DESIGN STATEMENT

COLLEGE LANE - CAMDEN

Design Statement

The statement supports a Section 73 application under the Town and Country Planning Act 1990 for minor material amendments to planning consent 2019/2623/P. Key amendments include:

FIGURE 4 BLOCK 3 PROPOSED LOWER GROUND FLOOR PLAN

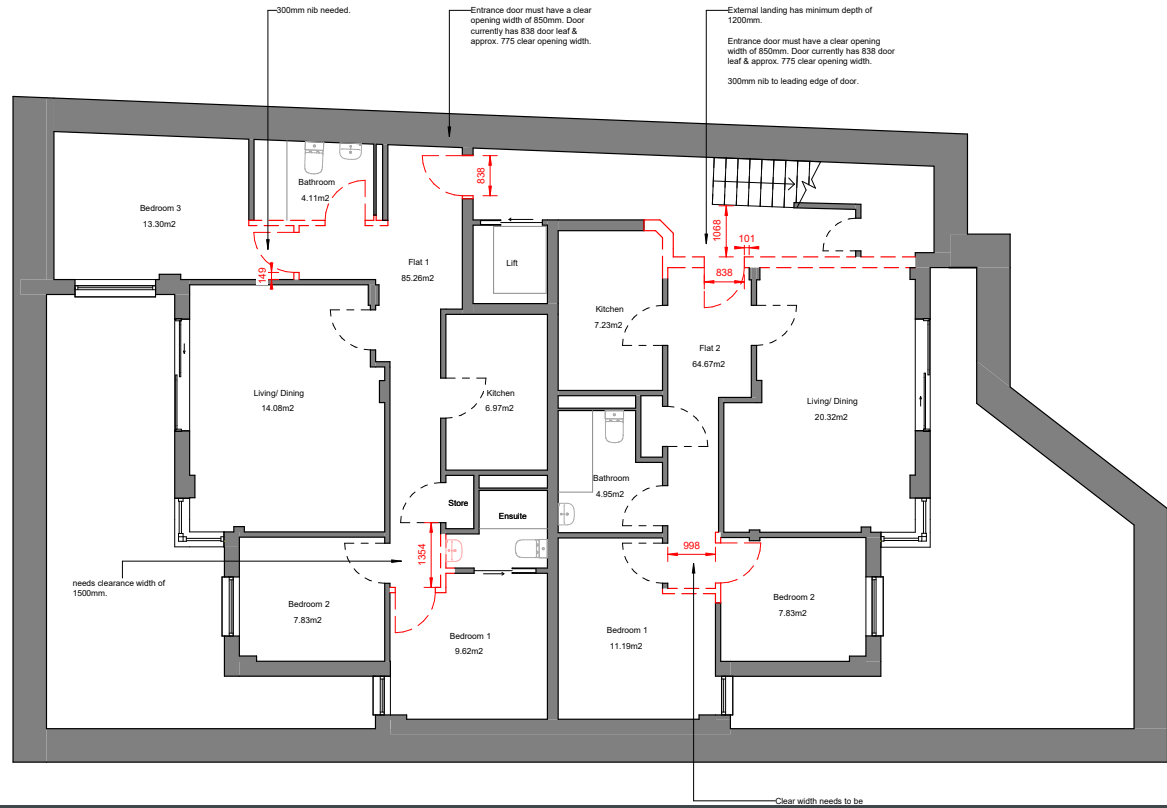
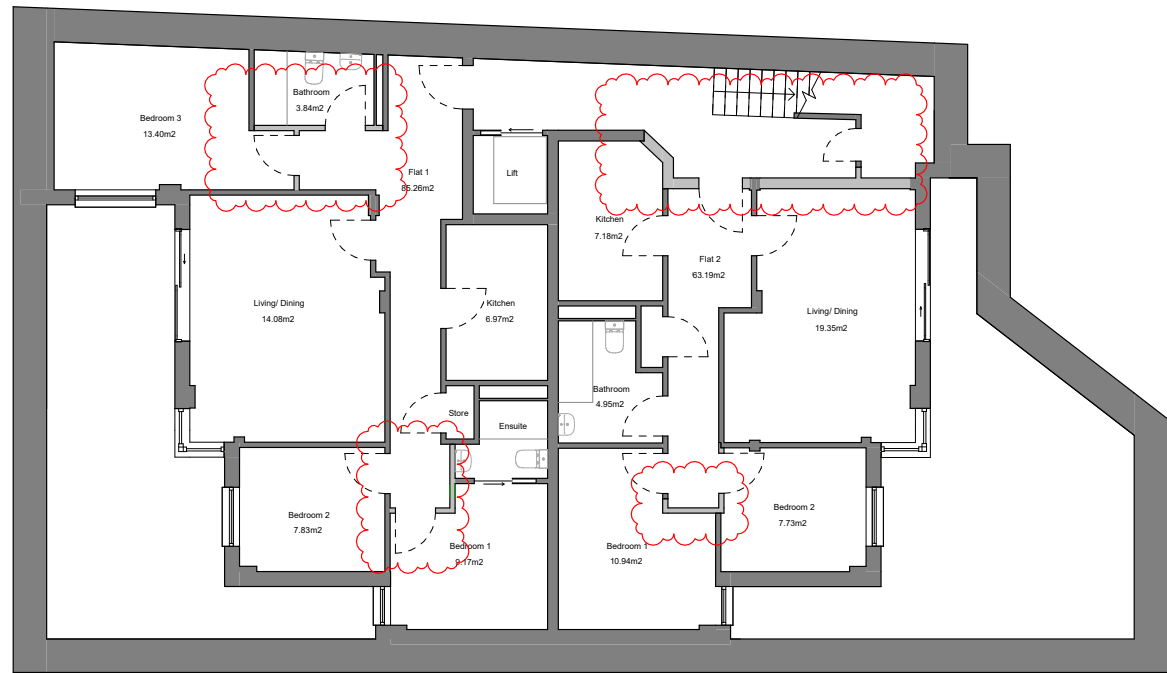
The external landings at both the lower ground floor and ground floor levels of the staircase did not meet the required minimum depth of 1200mm. In the existing condition, the depth of the landings measures 1058mm at the lower ground floor level and 1068mm at the ground floor level, at their widest points. This issue has been addressed by relocating the perimeter walls of Flats 2 and 4 to provide the necessary space for the landings. The updated flat and room areas are shown on the proposed plans.

FIGURE 6 BLOCK 3 PROPOSED GROUND FLOOR PLAN

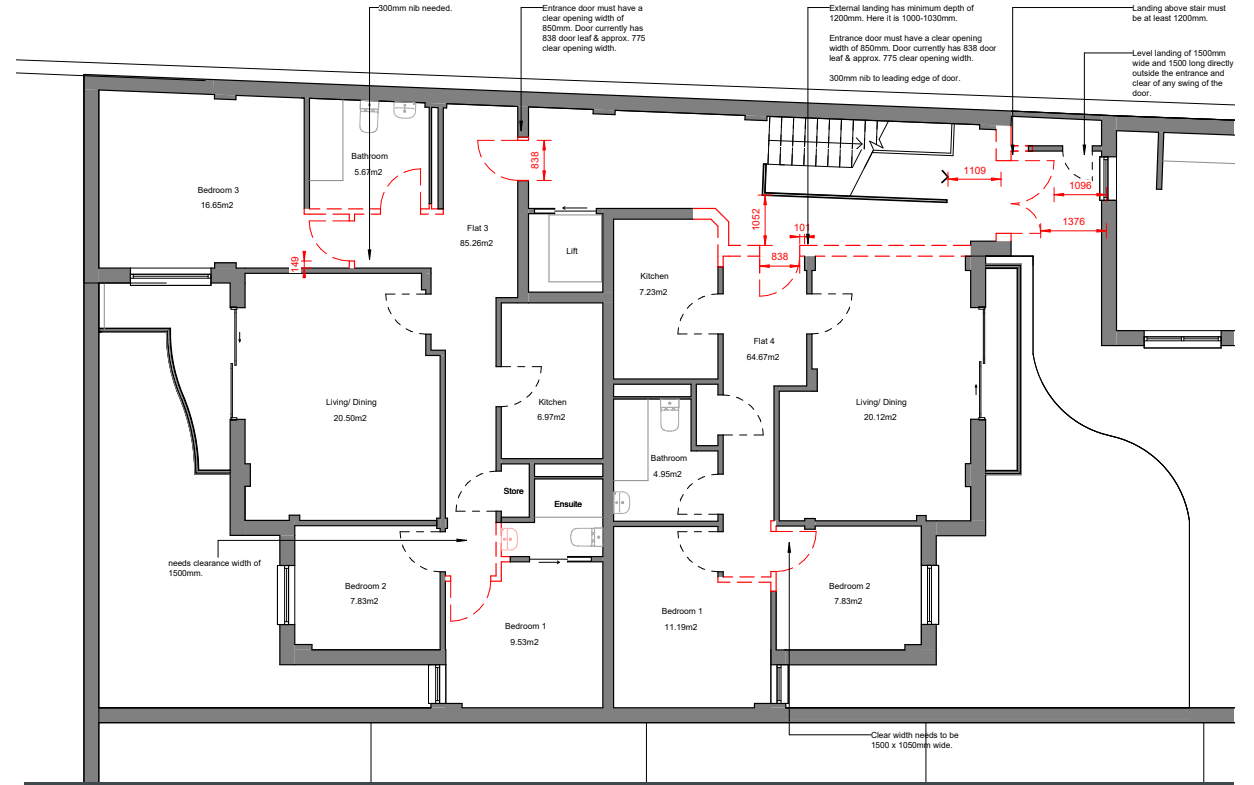
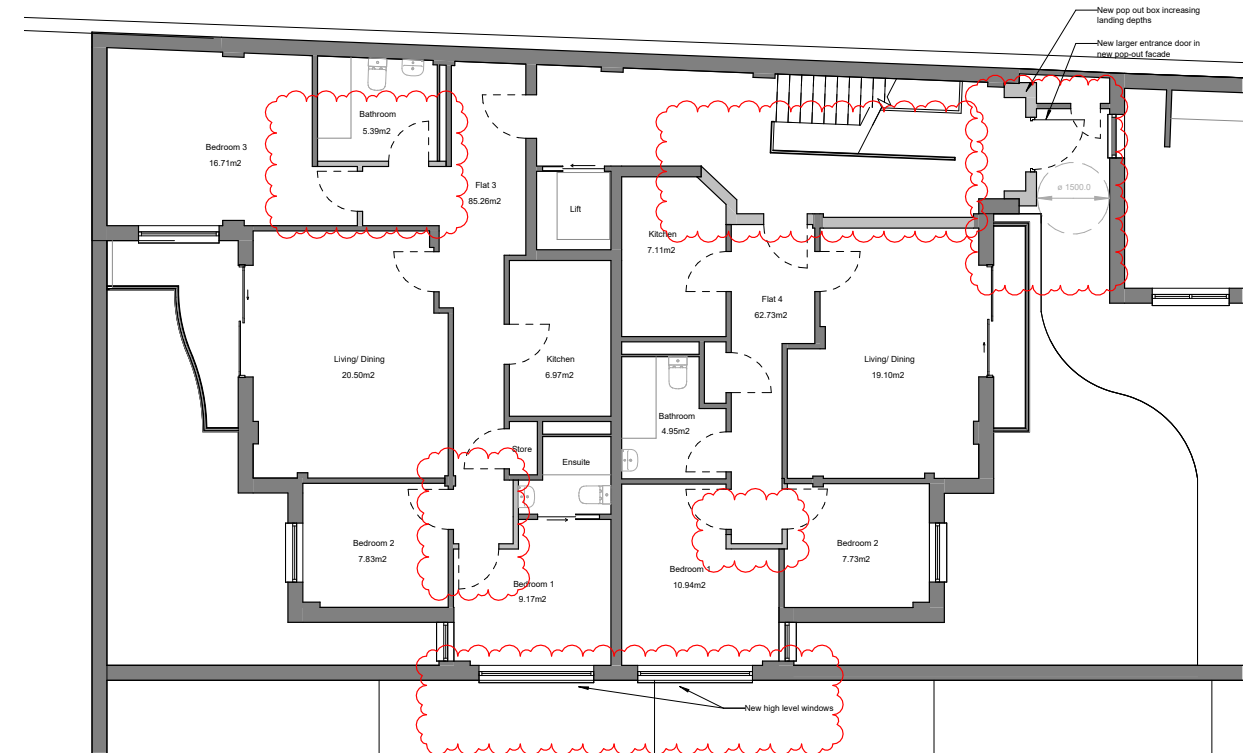
On the ground, first, and second floors, the existing landing above the stairs measures 1109mm, 1016mm, and 1131mm, respectively, falling short of the required minimum depth of 1200mm. To address this efficiently, it is proposed to extend the floor depth at these levels by modifying the external facade.

The ground-floor entrance landing was obstructed by the swing of the double doors, failing to meet the minimum space allowance for wheelchair users. The proposed large single-leaf door, to be installed on the new pop-out facade, will eliminate door swing conflicts and ensure compliance with the required 1500mm by 1500mm landing space.

FIGURE 8 BLOCK 3 PROPOSED FIRST FLOOR PLAN

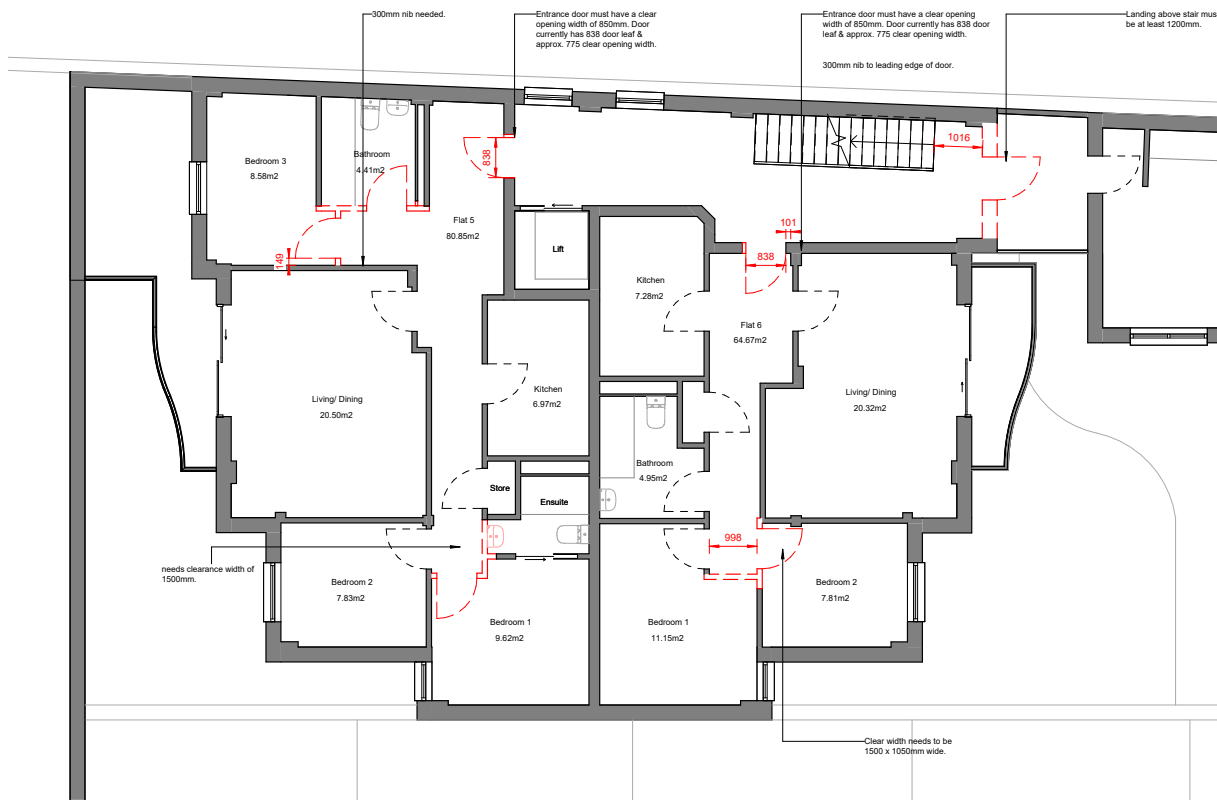
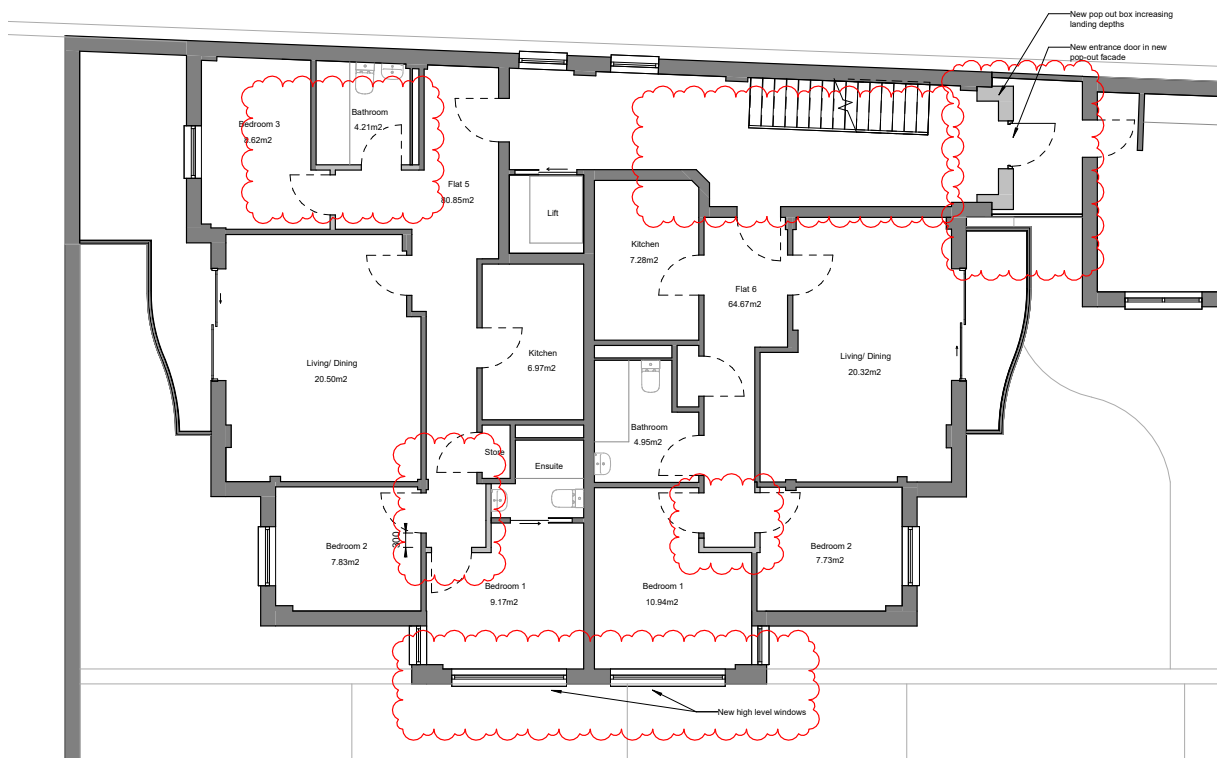
The facade will incorporate new doors and a window. The ground-floor entrance door and first-floor corridor door connecting the two buildings will be replaced and relocated. A new second-floor window is also proposed to enhance natural light in the landing area.

FIGURE 12 BLOCK 3 PROPOSED ROOF PLAN

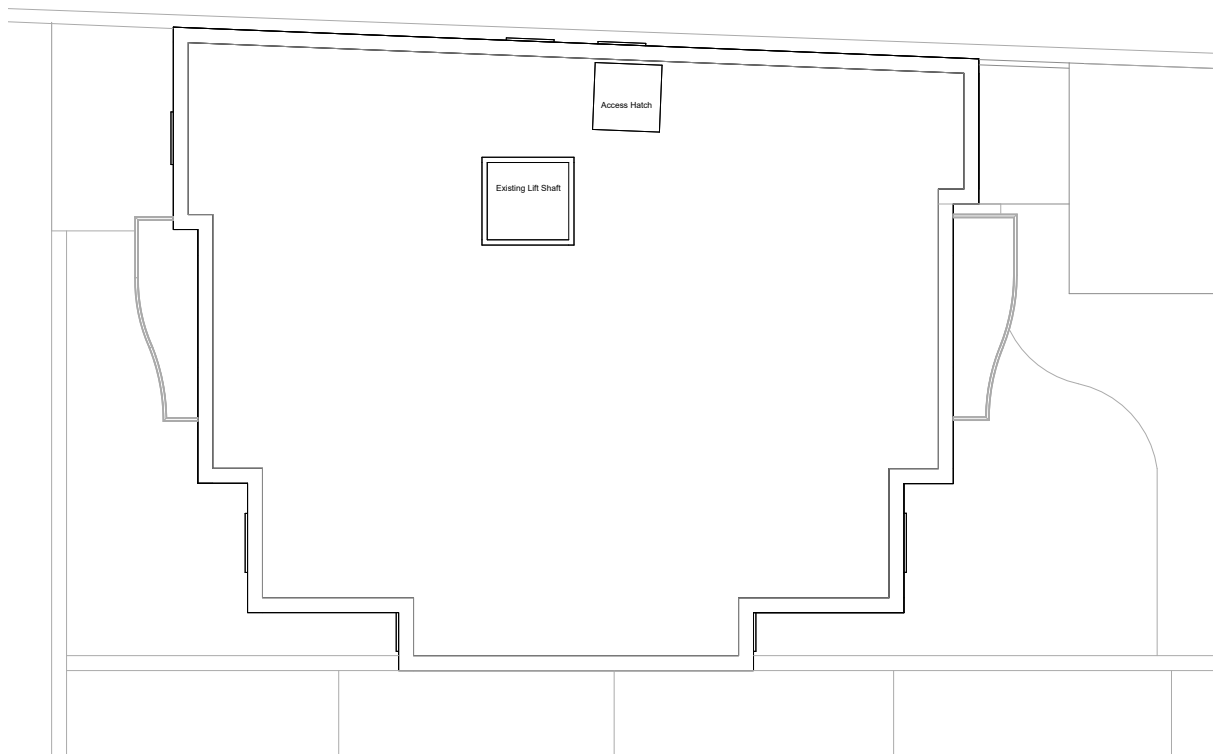
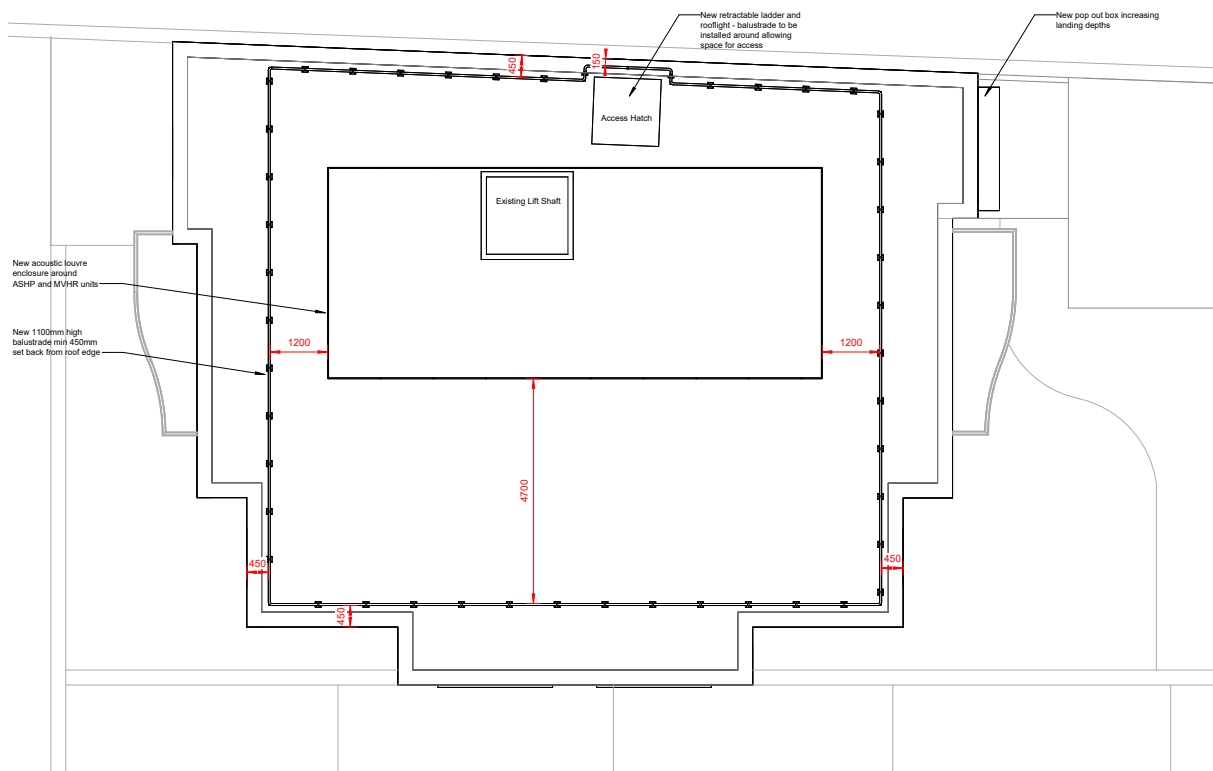
It is proposed to install a new retractable ladder and rooflight into the existing roof light opening.

A new 1100mm-high balustrade is proposed for installation on the roof to ensure safe access. It will be set back at least 450mm from the roof edge and installed around the rooflight, providing adequate access space.

A new acoustic louvre enclosure is proposed to be installed around the new ASHP and MVHR units on the roof. The enclosure panels will be 2050mm high and set back from the roof edge to minimise the visual impact on the building. A minimum distance of 1200mm will be maintained from the new balustrade to ensure sufficient clearance.

FIGURE 14 BLOCK 3 PREVIOUSLY APPROVED AND PROPOSED ELEVATIONS

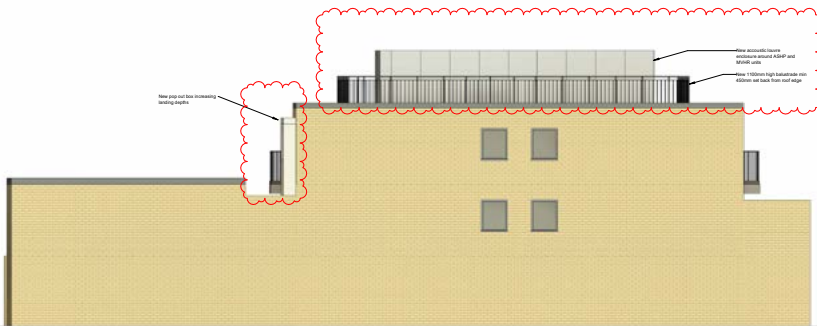
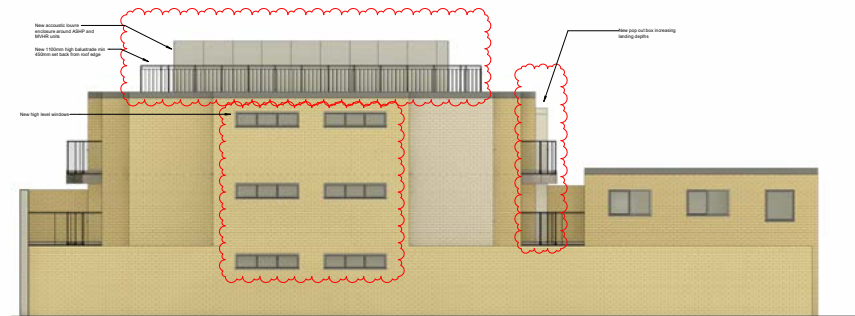
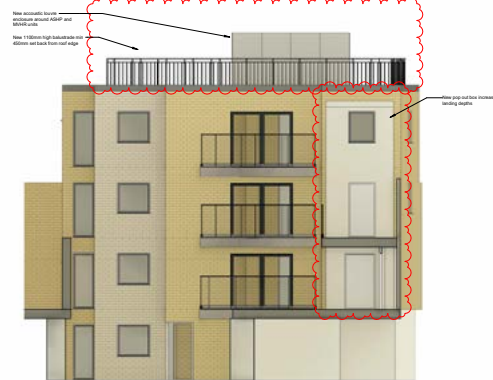
The new pop-out facade will accommodate the landing depth adjustments across all affected levels. Materials for the facade and roof will be carefully selected to match the existing building’s palette, ensuring consistency with its aesthetic and character.
